**CONTAINMENT LINER TEST CHANNEL
AT
BEAVER VALLEY POWER STATION - UNIT NO. 1**

MARCH 1, 1979

**PREPARED BY
STONE & WEBSTER ENGINEERING CORPORATION
for
DUQUESNE LIGHT COMPANY**

NRC QUESTIONS AND RESPONSES

FIG.3(a)
SHEET 1 OF 2
TEST CHANNELS-FLOOR DETAILS

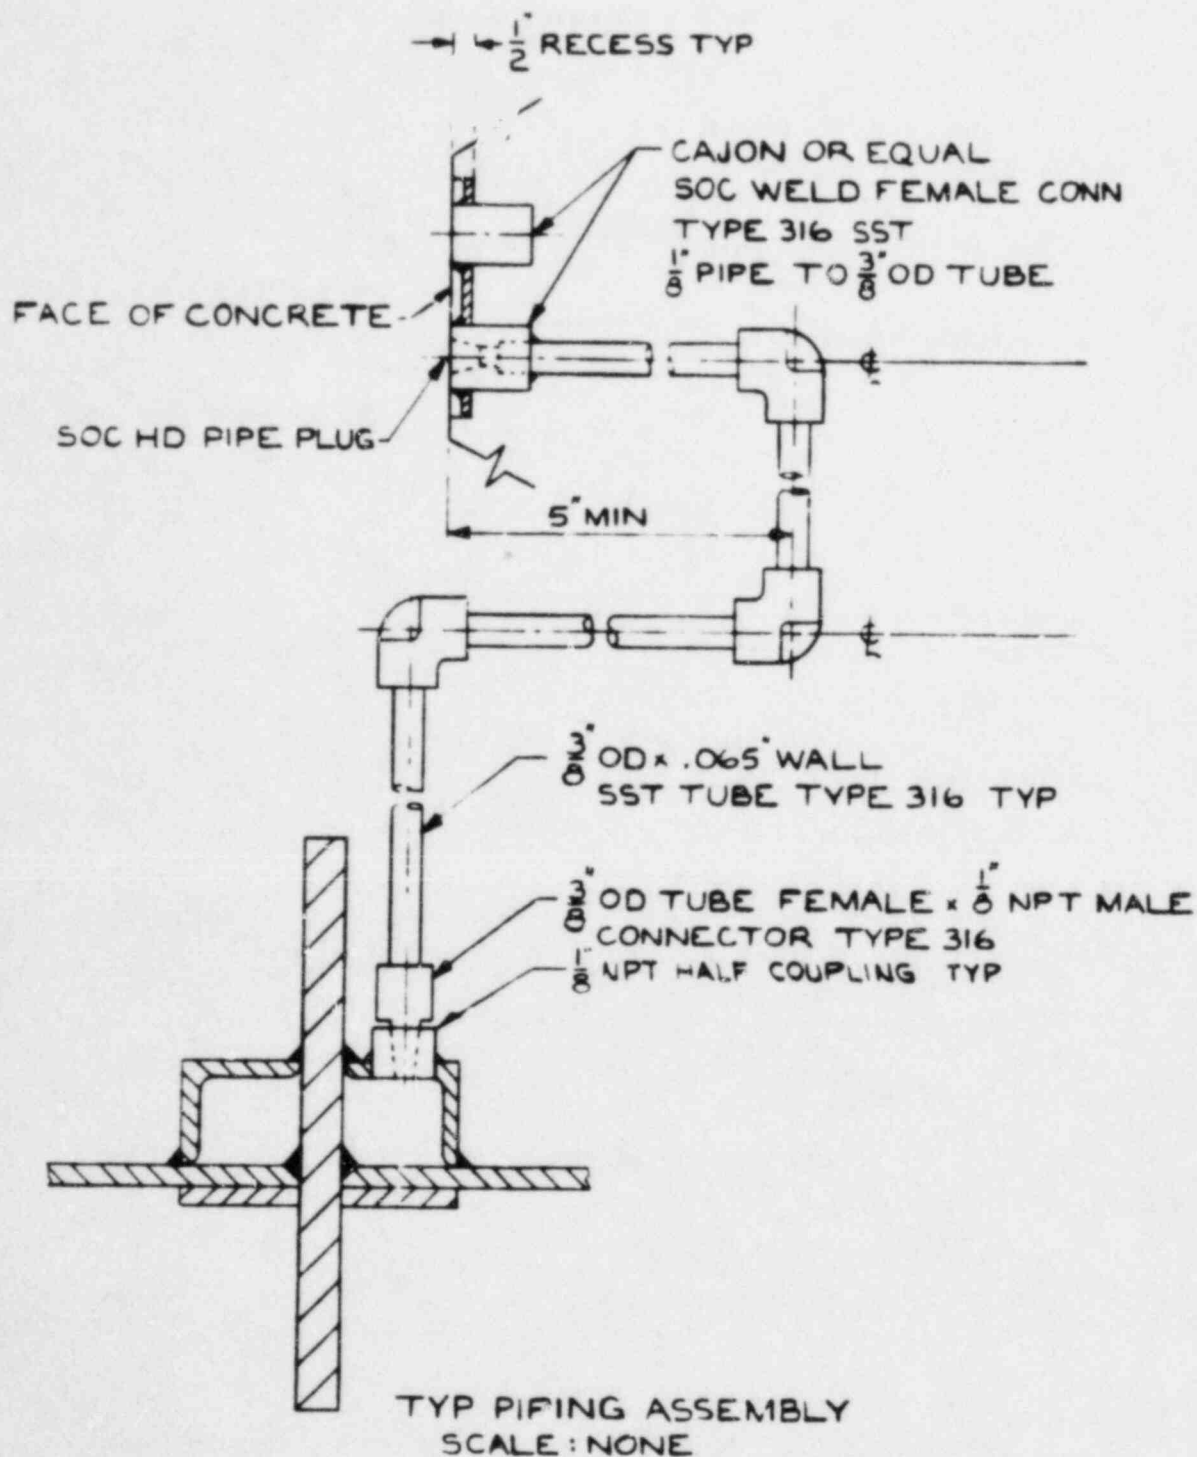
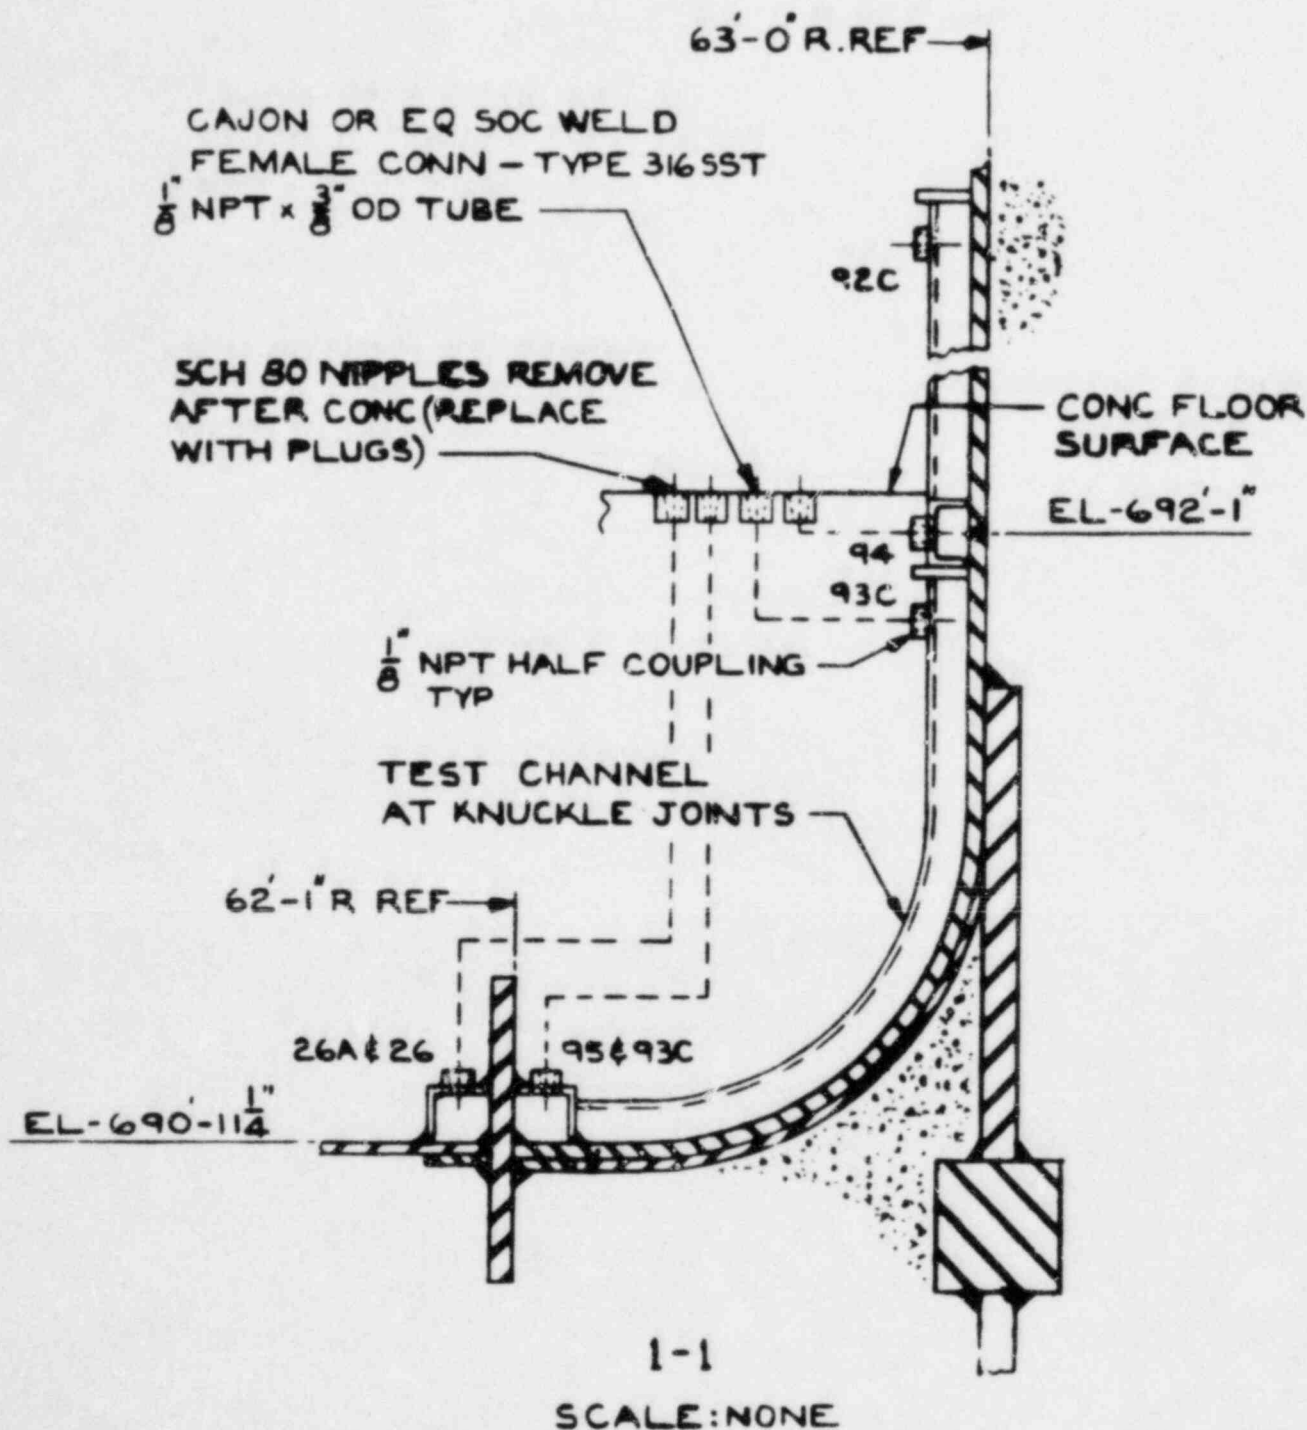
NOTE: In all of the above where procedures are requested but may not exist, describe the information or process in sufficient detail to permit NRC evaluation.

C.1 Plugs are installed in test channel test port panels to prevent seepage into the channels. These clusters of test connections are located in regions of the mat away from low spots inside containment and consequently would not trap water. Figure 2a locates the various test panels in the floor.

FIG. 3(c)
TEST CHANNELS-DOME DETAILS

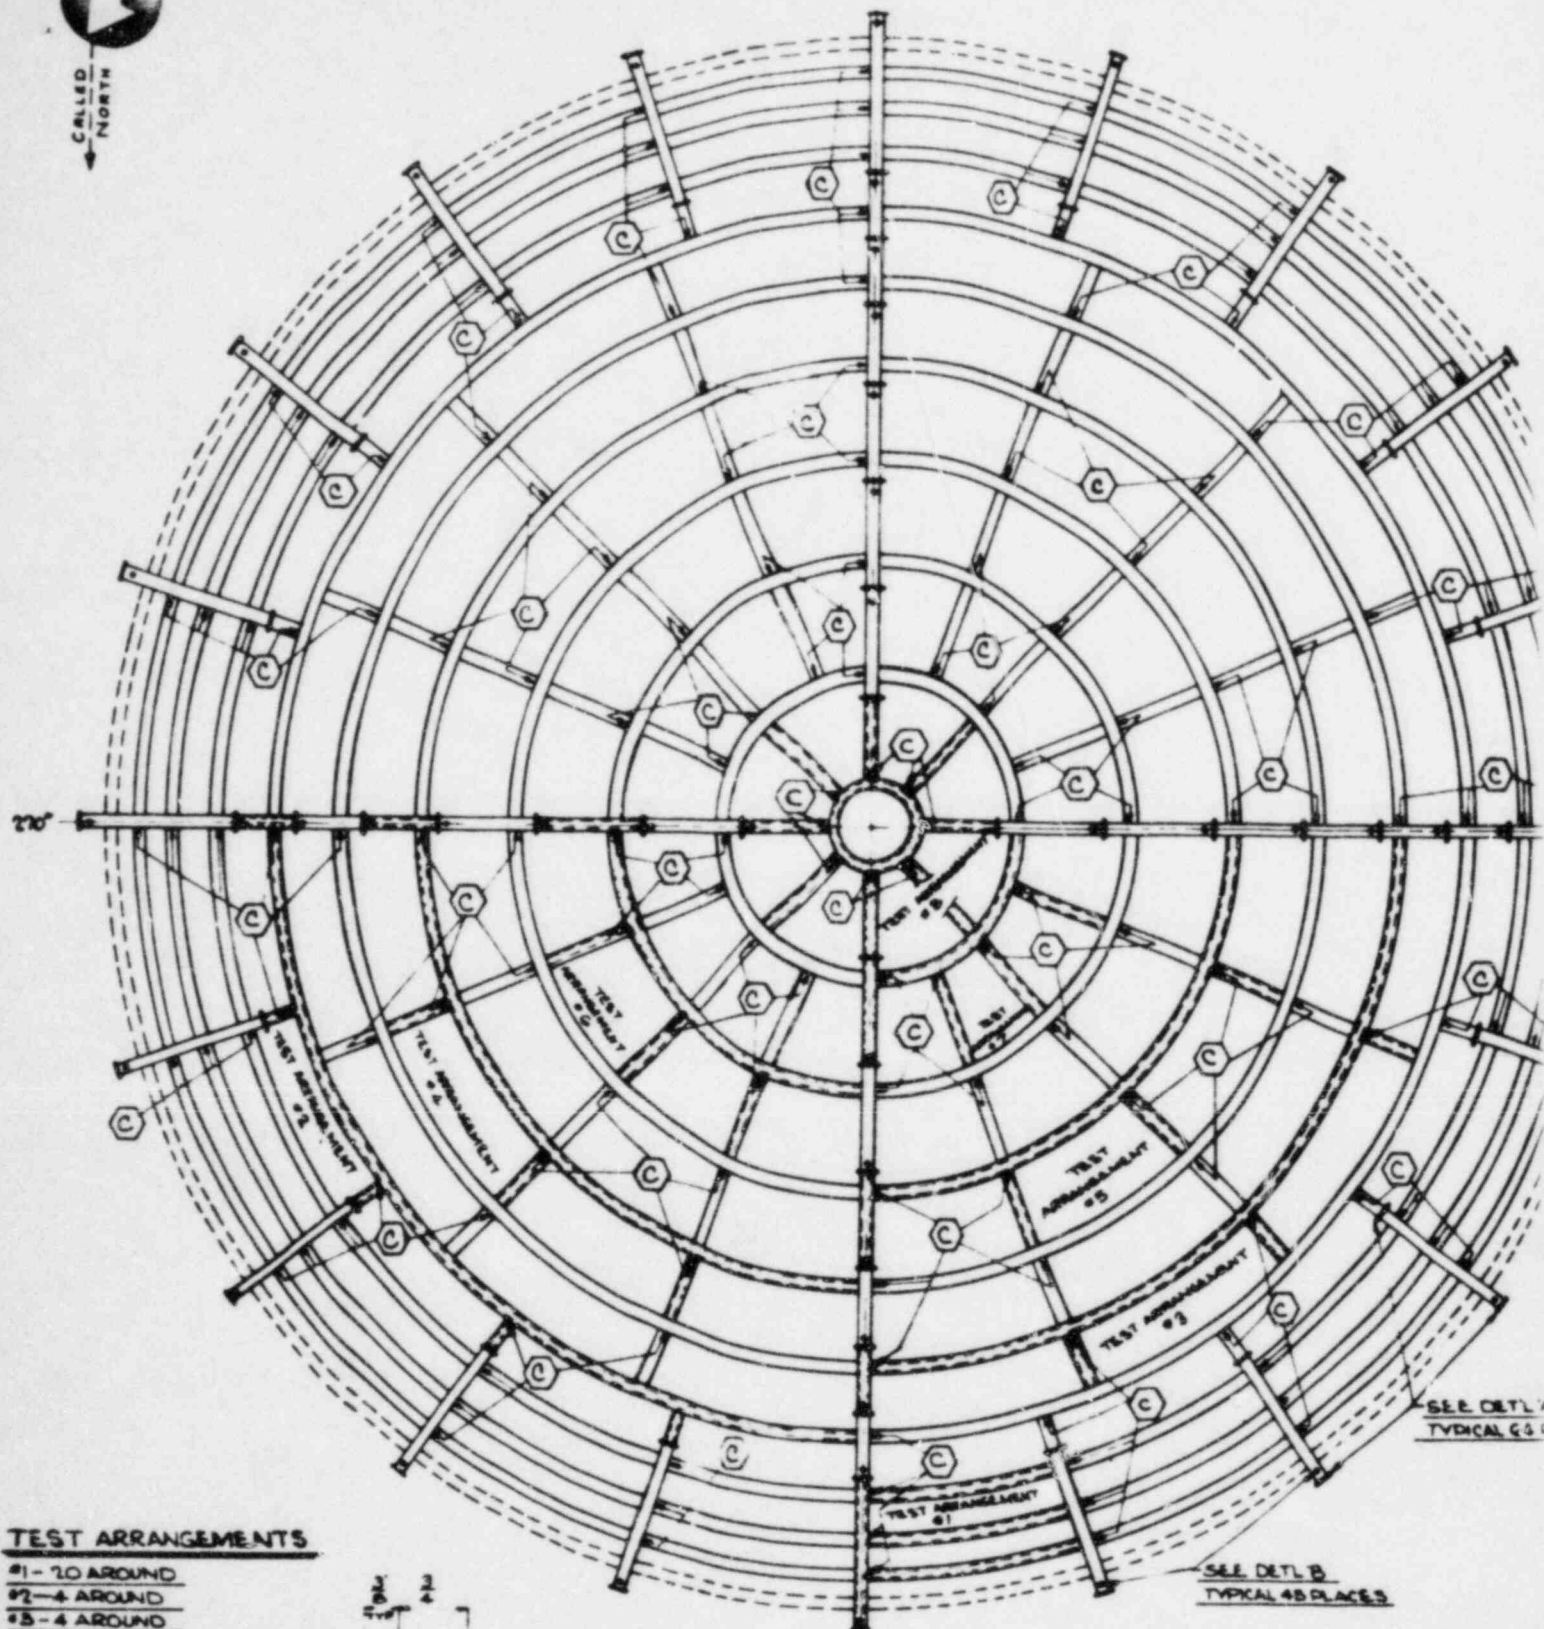
Provide as-built descriptions and drawings of the dome channel details specifically the plug assembly in the liner seam welds. Provide construction assembly procedures and address the immediate surroundings of the channel boxes on the exterior of the liner. Provide the basis for assuring these channel welds will hold against the shear forces if the liner moves against the concrete structure.

B.1 Figures 3c, 4 and 6 illustrate the details of the dome test channels.

FIGURE 5 CONTAINMENT LINER-STRAIN CURVES

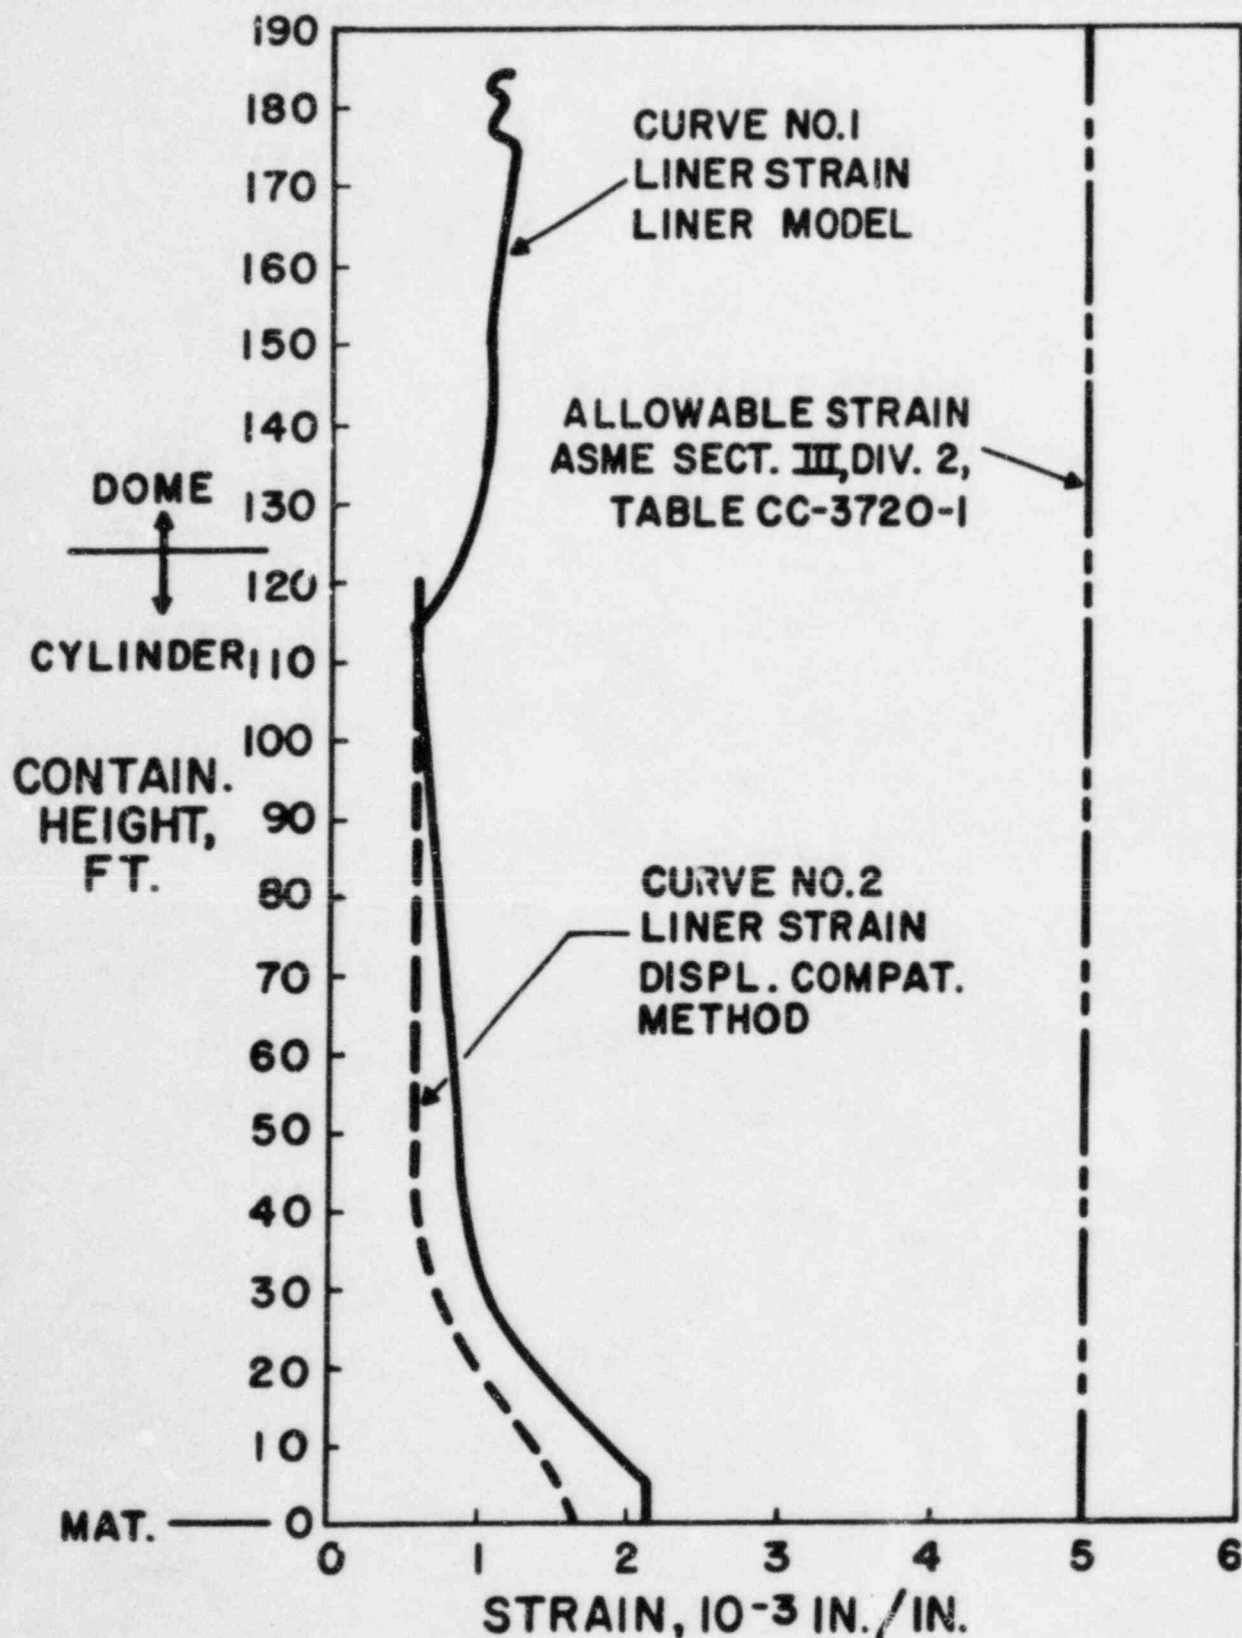
Provide an analysis which would demonstrate that the channels and channel welds will be capable of carrying the differential movement or expansion of the liner. Consider liner buckling or bulging due to Loss-of-Coolant Accident (LOCA) temperature and dynamic pressure effects and seismic loads. Provide a comparative analysis to demonstrate leak channels and their welds meet the requirements of the ASME Boiler and Pressure Vessel Code Section 3, Div. 2, as appropriate.

The current industry code applicable to the design of containment liners is ASME Section III, Division 2. This code recognizes that liner forces are displacement limited and provides liner allowables in inch/inch of strain. In order to compare stress results with current code strain limits, the membrane and bending stresses calculated by elastic theory have been converted to strain (by dividing stresses by the Modulus of Elasticity) and are plotted in Figure 5, Curve No. 1. Since these strains are mostly membrane strain, they are conservatively compared in the figure to the lower code allowable for membrane strain of 5×10^{-3} in/in. (The code allowable for membrane plus bending is 14×10^{-3} in/in.)

The above approach was checked by consideration of displacement compatibility between the liner and the reinforced concrete wall using the resulting displacements from the analysis of the reinforced concrete structure. This results in lower liner strains as indicated by Curve No. 2 in Figure 5.

made by assuming that the strain in the TC is the same as that of the liner to which it is attached. (This is conservative since the liner strains are very conservatively calculated.) As indicated in Figure No. 5, liner strains (and, therefore, TC strains) are well below the ASME allowable membrane strain of 5×10^{-3} in./in. Calculations indicate that the liner has a factor of safety of 1.8 against buckling based on the very conservative liner stress calculation. The local presence of test channels tends to stiffen the liner, thereby further reducing any potential for buckling. Since bending stresses are small, the TC attachment welds are subjected primarily to the same membrane strains as the liner and would have the same margin against the 5×10^{-3} in./in. code strain allowable.
